Staff Report to the
Development Review Committee
March 9, 2023

MPL2023-10006

LAKE NONA PARCEL 20A OFFICE COMPLEX

Site Plan

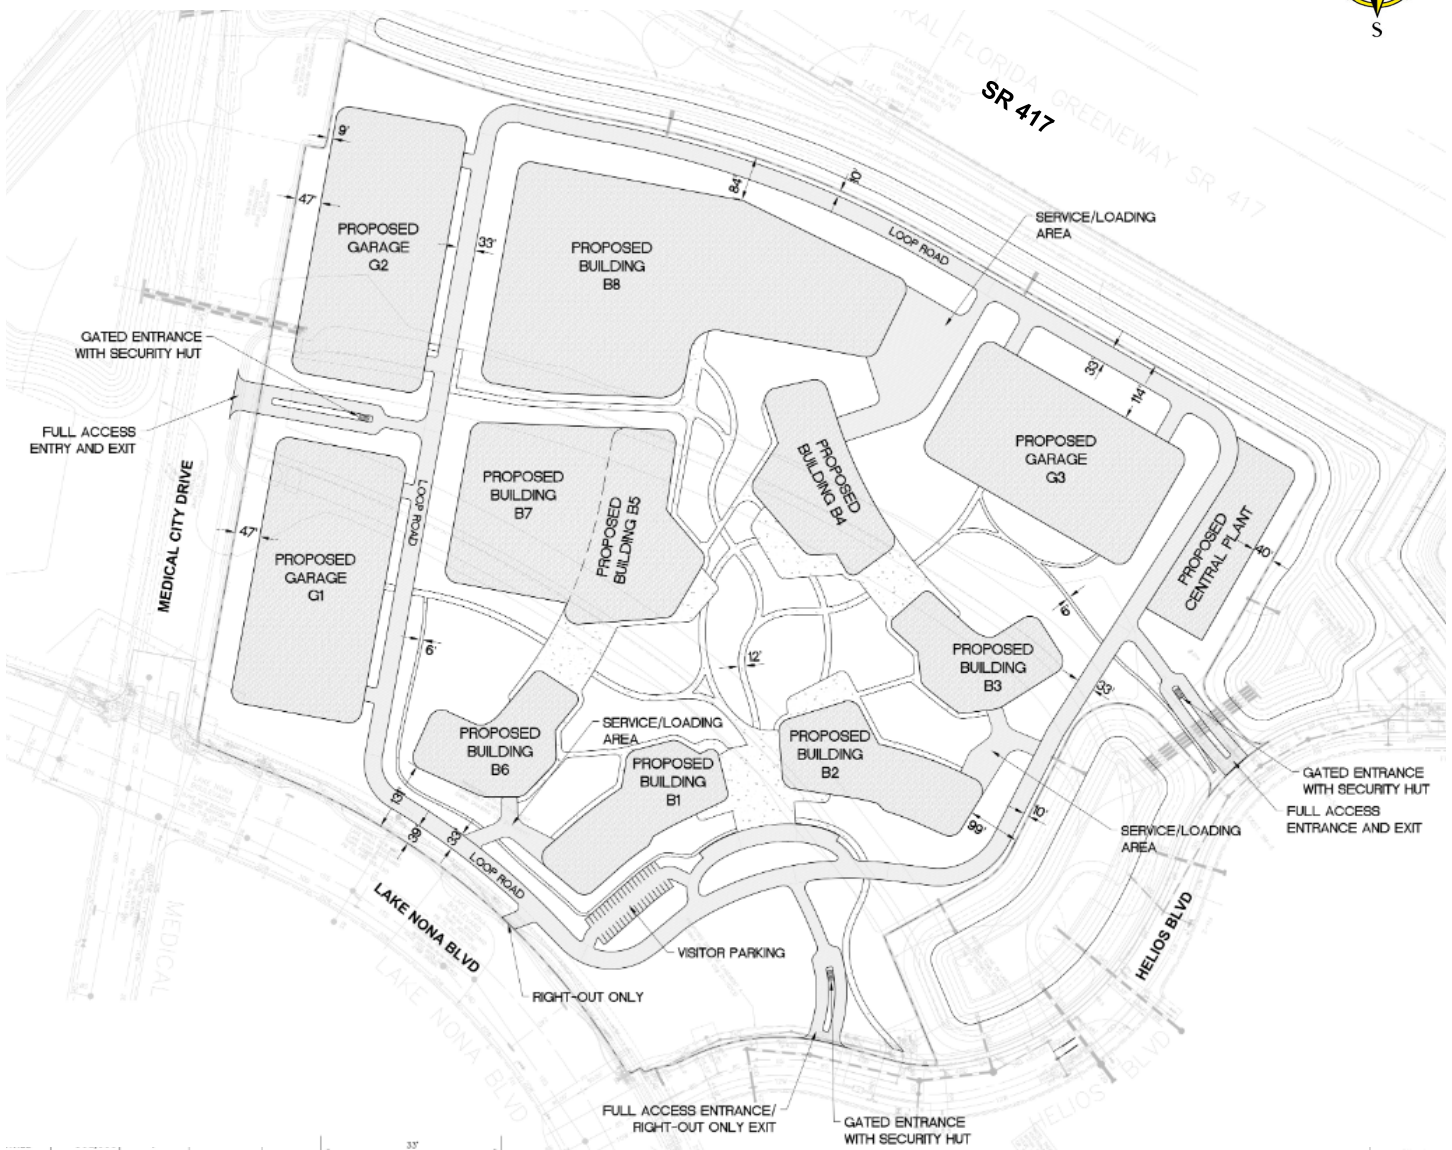
- A. Between Garage G-1 and Building B7
- B. Between Garage G-2 and Building B8
- C. Between the southern Helios Blvd. entry and Building B2

- A. Private Maintenance: The driveway labeled loop road may operate either as a driveway or private roadway but must remain privately owned and maintained, it will not be public ROW.
- B. If the desire is to have loop road be designated as a private roadway then it must be designed in conformance with the requirements for public streets set forth in Chapter 61, Part 2C.
- C. It is recommended that the cross section of the loop road be reduced to discourage speeding and enhance pedestrian safety. The minimum pavement width is 20 ft.
- D. A 6ft. sidewalk must be installed along at least one side of the loop road. It is recommended that a landscape strip be included between the sidewalk and travel lane.
